NOV_SCE_ATJ_ 20211202-01

NOTICE OF VIOLATION

Energy Safety Inspection Report

On December 2, 2021, I performed a walking inspection of Southern California Edison (SCE) covered conductor installations, 2021 WMP initiative number 7.3.3.3.1, along Ridge Route Road and North Gate Road near the city of Castaic, California. Detailed findings from this field inspection are laid out in Section II below.

Structure ID: 45377945E

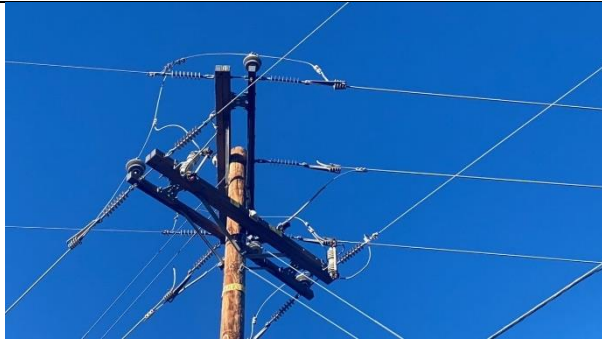
Item1IA1img1: Pole ID

Item1IA2Img1: Overall pole phases

Item1IA2Img3: Bare conductors

Structure ID: 4628153E

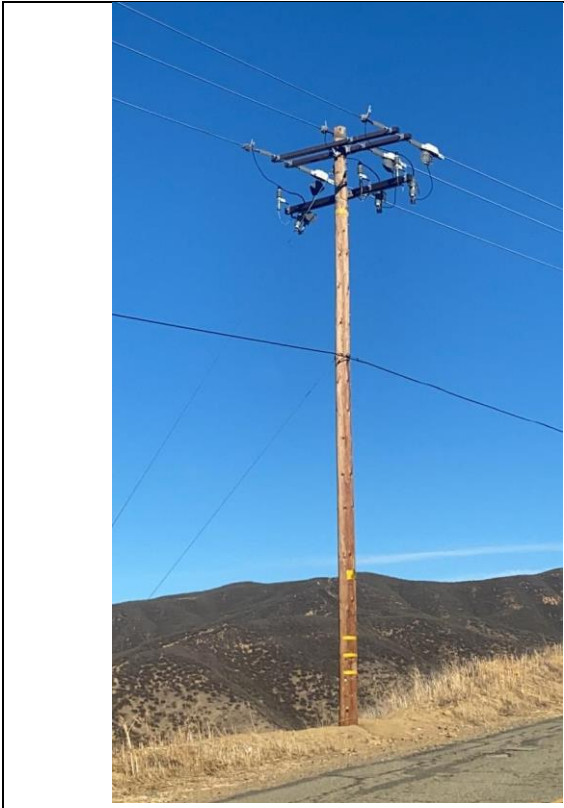
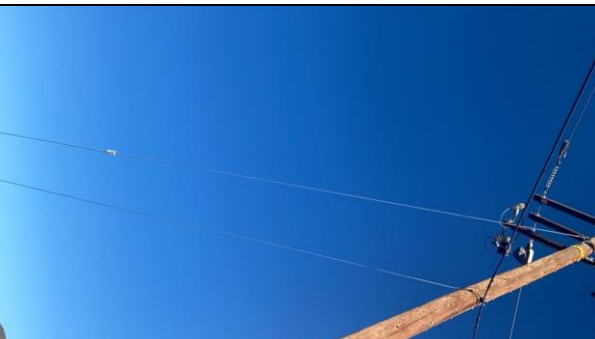
Item2IA1Img1: No vibration dampers

Item2IA3Img1: No bolted wedge connector covers when transitioning from bare to covered conductor

Item2IA4Img1: Porcelain down guy

Structure ID: 710834E

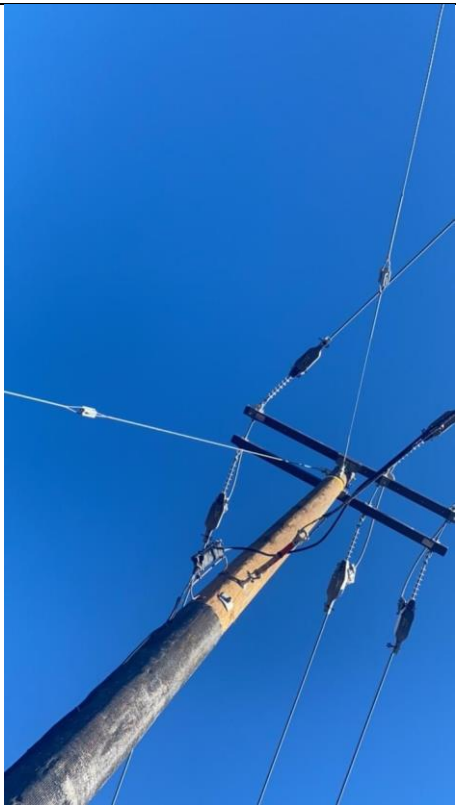
Item3IA1Img1: No vibration dampers

Item3IA2Img1: Porcelain guy insulators

Structure ID: 862693E

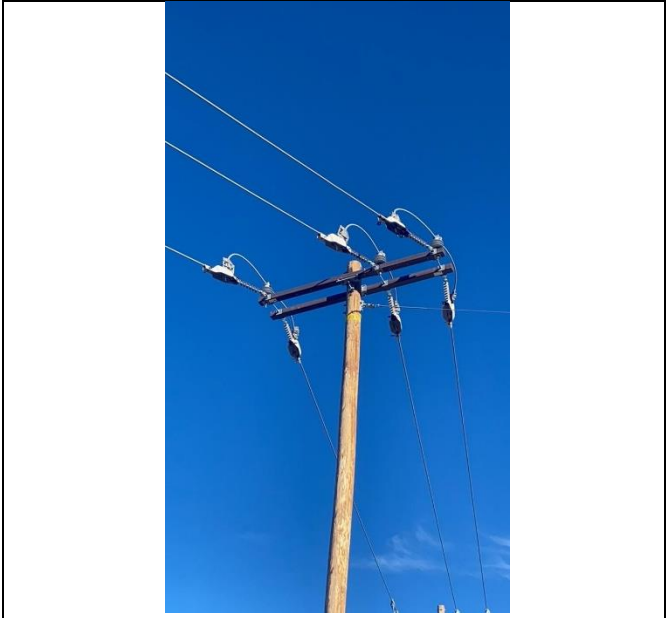
Item4IA1Img1: No vibration dampers

Item4IA2Img1: Porcelain guy insulator

Structure ID: 4724215E

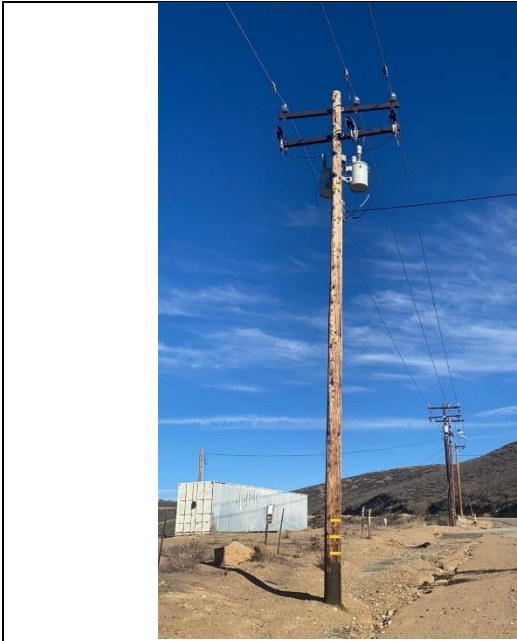
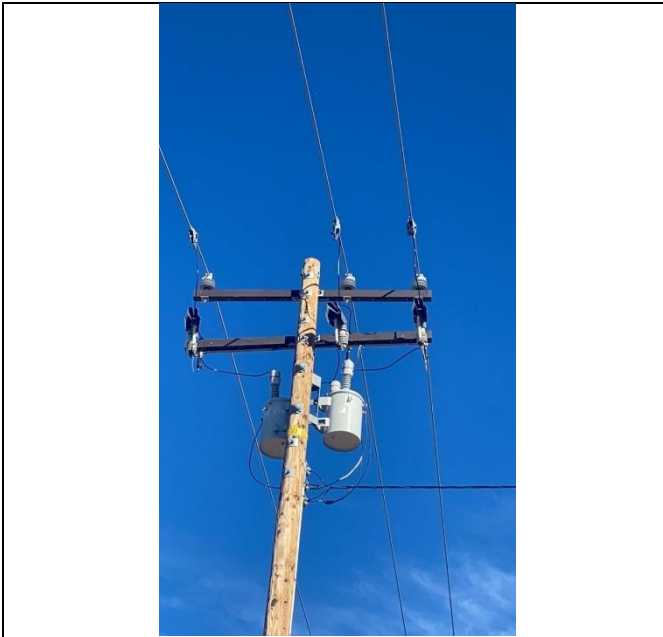
Item6IA1img1: No vibration dampers

Structure ID: 4393705E

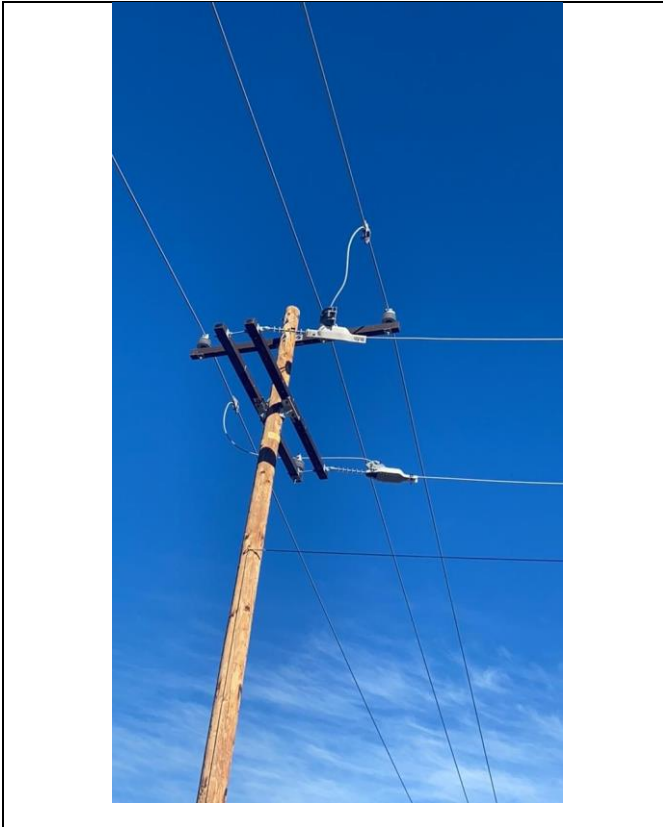
Item8IA1Img1: No vibration dampers

Structure ID: 4393713E

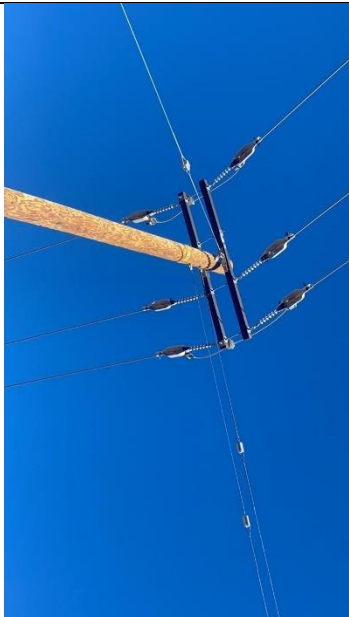
Item9IA1Img1: No vibration dampers

Item9IA2Img1: Three guy wires with porcelain insulators

Structure ID: 4308815E

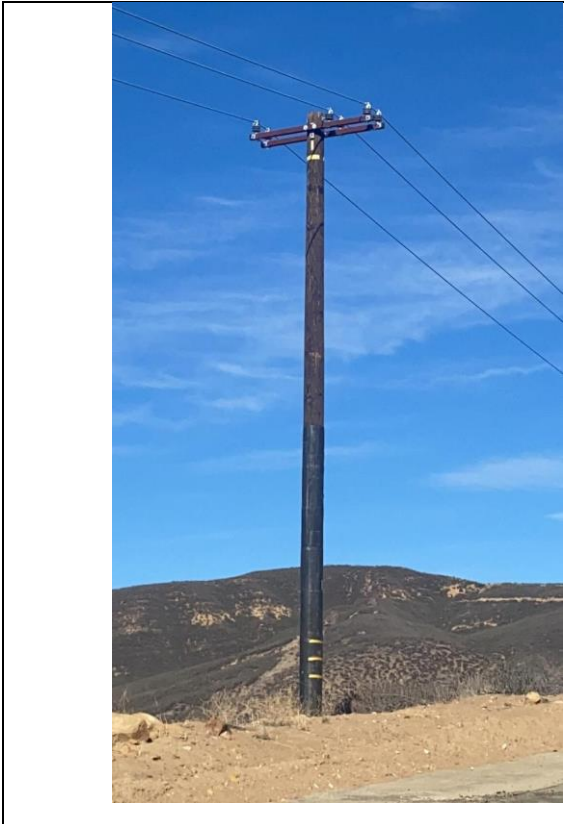
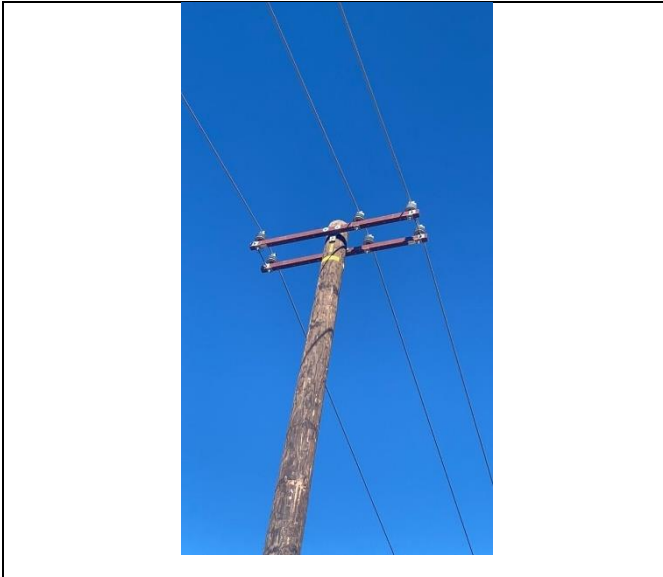
Item10IA1img1: No vibration dampers

Structure ID: 862696E

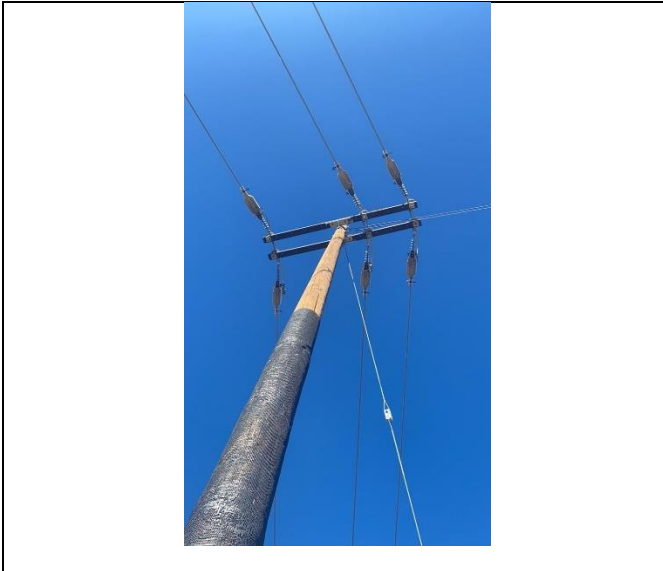
Item11IA1Img1: No vibration dampers

Item11IA2Img1: Porcelain guy insulators on three guys

Structure ID: 4308816E

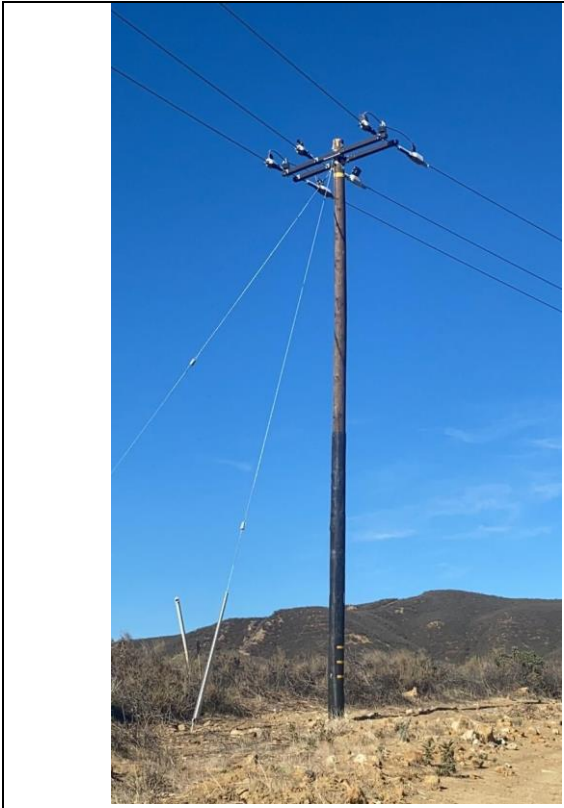
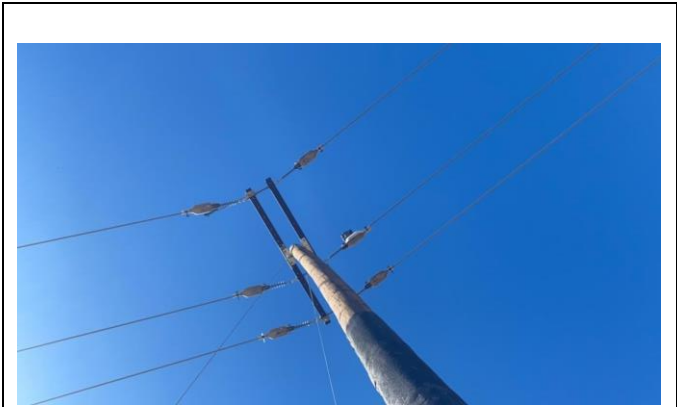
Item12IA1Img1: No vibration dampers

Item12IA2Img1: Porcelain guy insulators on two guy wires

Structure ID: 4789750E

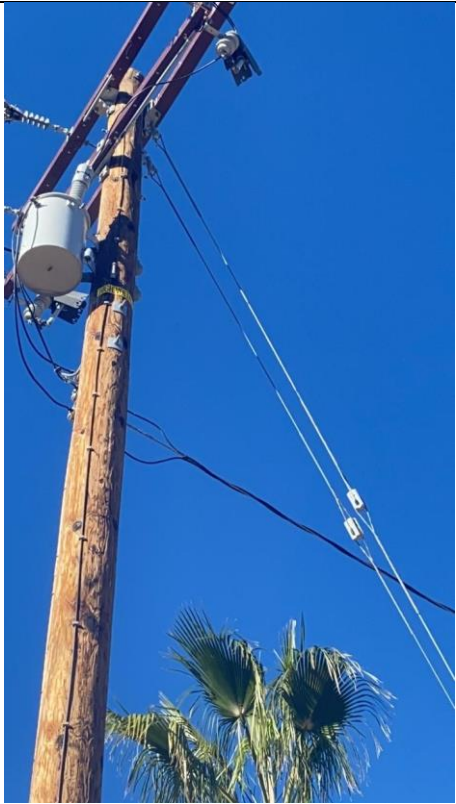
Item14IA1img1: No vibration dampers

Item14IA2Img1: Porcelain insulators

Structure ID: 4568486E

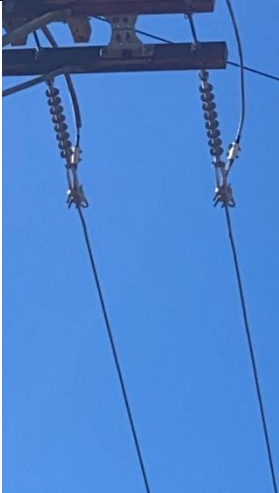
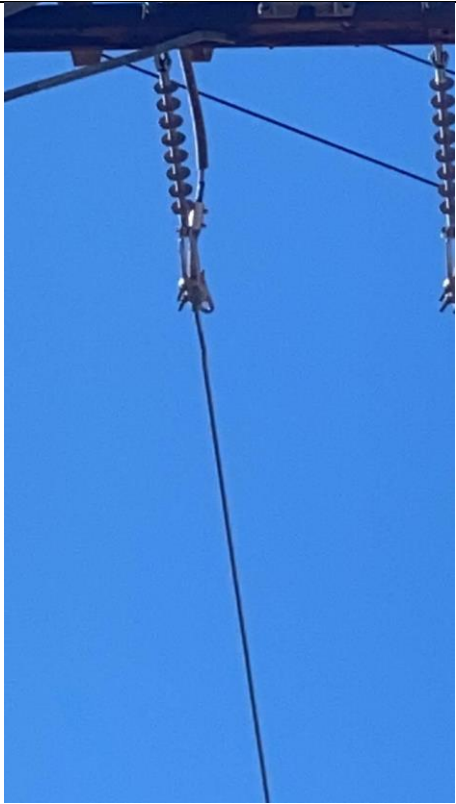
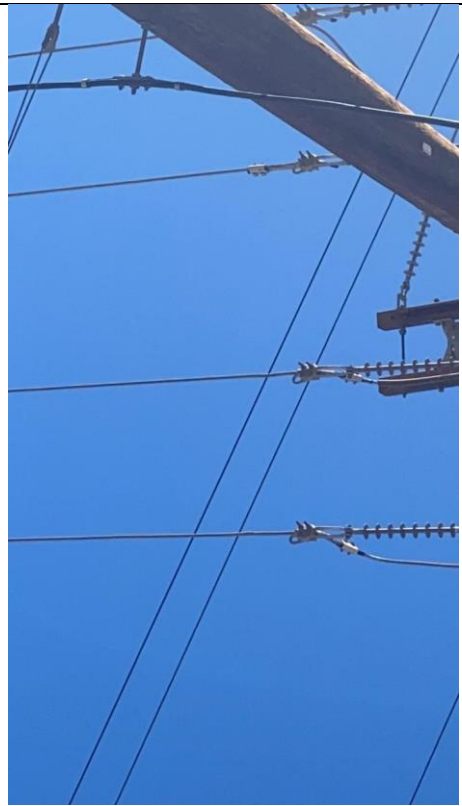
Item15GImg3: Bare wire on all phases closeup

Item15IA1img1: Bare conductor

Item15CD5Img1: Close up of phase bird caging

Item15CD5Img2: Overall view, bird caging on bottom phase
